CITY OF MILWAUKIE

To: Planning Commission

Date: August 27, 2019, for September 10, 2019, continued Public Hearing

Subject: **File:** NR-2018-005 (master)
Applicant: Gillis Properties, LLC
Owner(s): Same
Address: 12205-12225 SE 19th Ave
Legal Description (Map & Tax Lot): 11E35DD 03200 & 03300
NDA: Island Station

Figure 9. View corridors

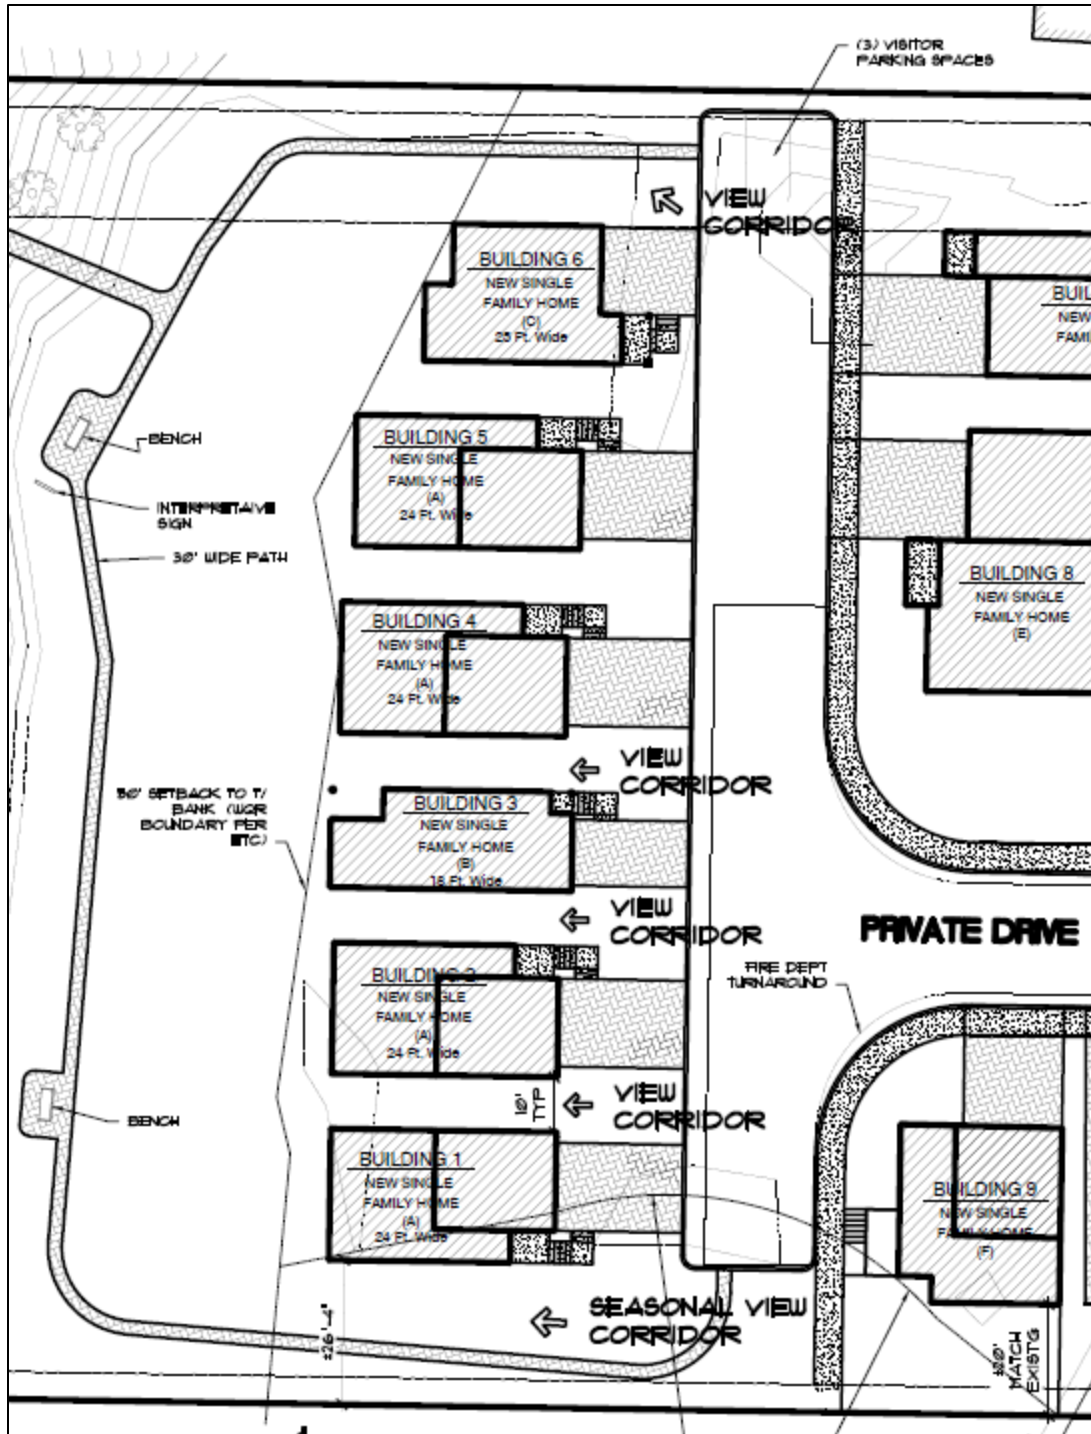
The presence of Elk Rock Island blocks any views directly west across the property, in addition to dense vegetation that blocks views in the summer months. But, as shown above, there are portions of the river that are visible from the public right-of-way in the winter and spring. The proposed site plan identifies view corridors from the right-of-way (see Figure 9). It appears that the proposed development will provide some narrow views to the river. Numerous comments were received related to this issue and they unilaterally opposed the development based on its impact on views.

The overall views from the public right-of-way toward the river are limited today and do not appear significant enough to preclude approval of the WG conditional use application.
